26 June 2003
Reference: 1922.01

I have responded to your comments in your 25 June 2003 email regarding ERM's proposed verification sampling plan for the wetlands remediation project at the former Raytheon facility in Wayland, Massachusetts (Figure 1). Your comments are in italics.

Figure 2 - Verification Grid

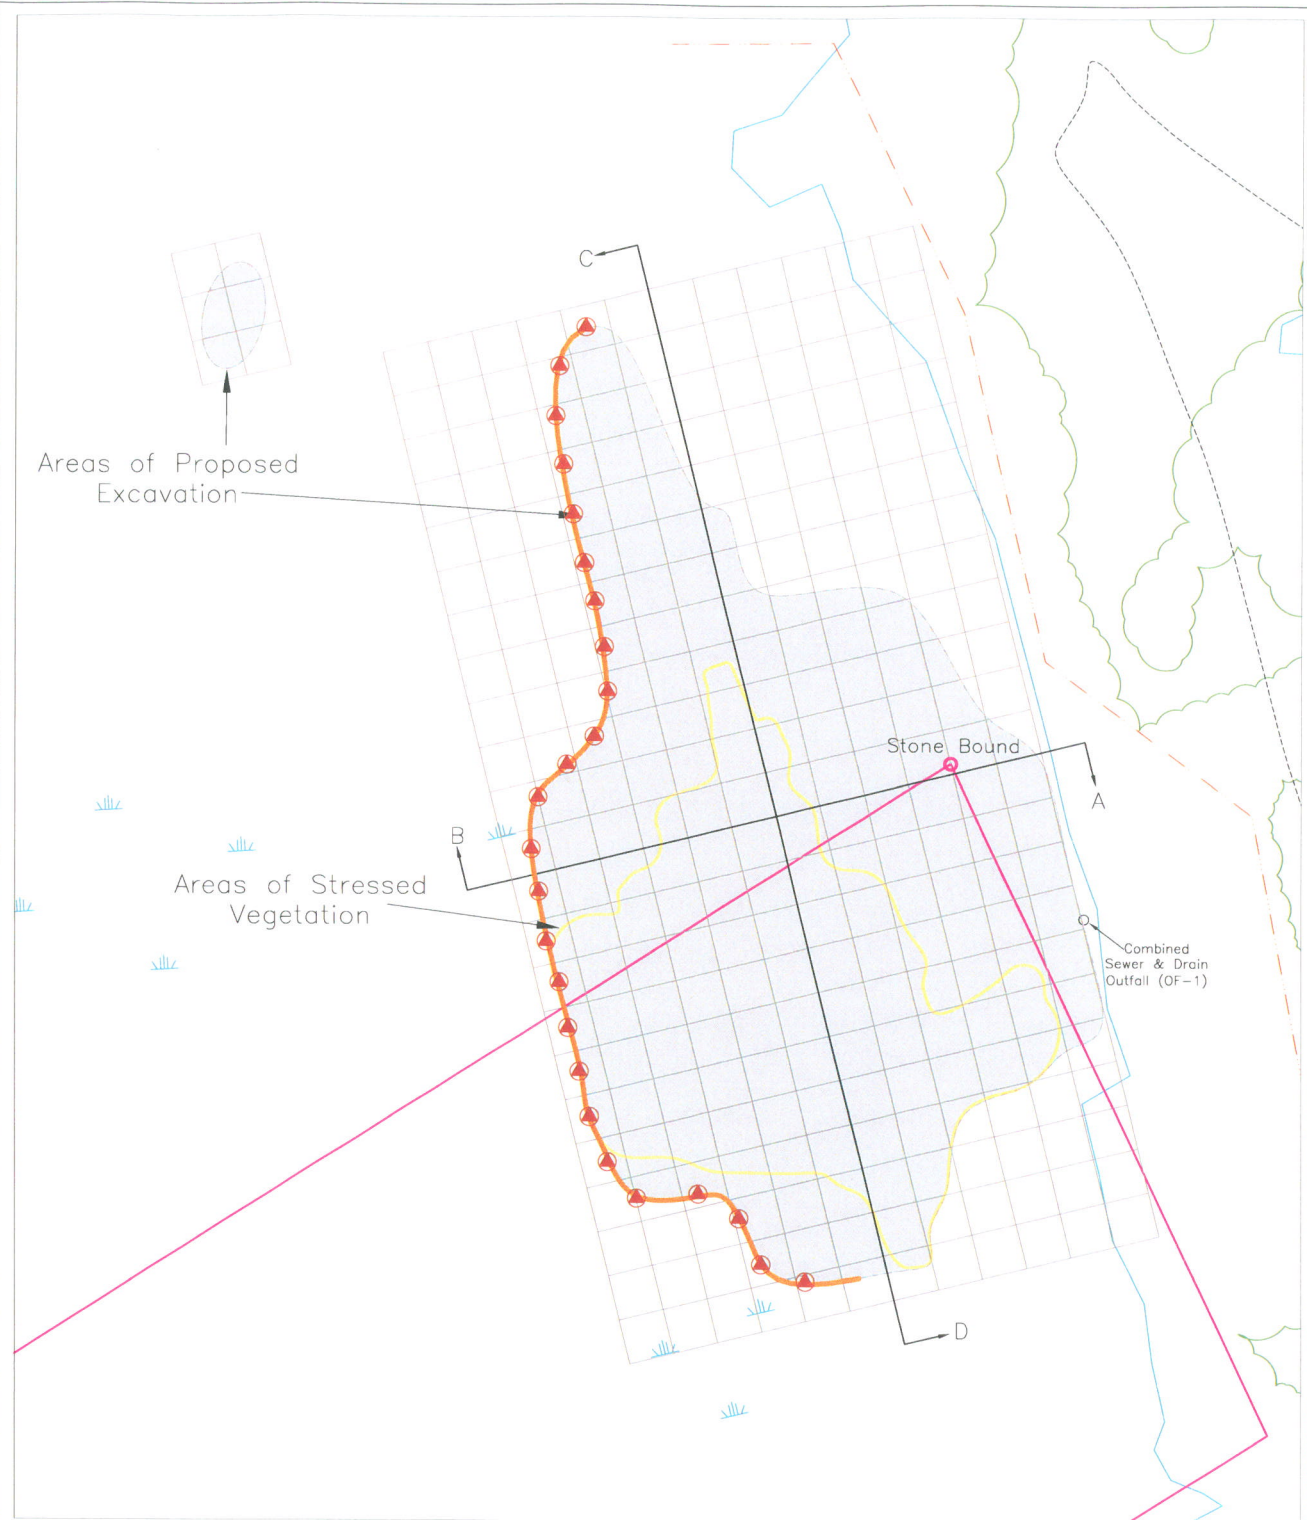
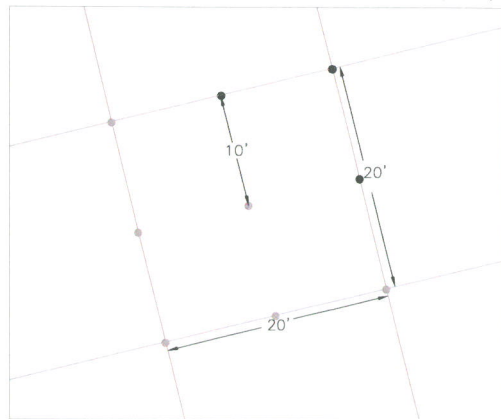
For reasons that are opaque to me, §761.283(b)(1)(i) requires that you orient the sampling grid to magnetic north. All the remediation figures I recall seeing are oriented to true north. (In the attached PowerPoint file, I followed the magnetic north procedure.)

Although the strict requirements of this section does not apply to Raytheon's application, yes, we were also aware of this oddity in the regulation and have since revised all of our Site figure to be oriented to magnetic north.
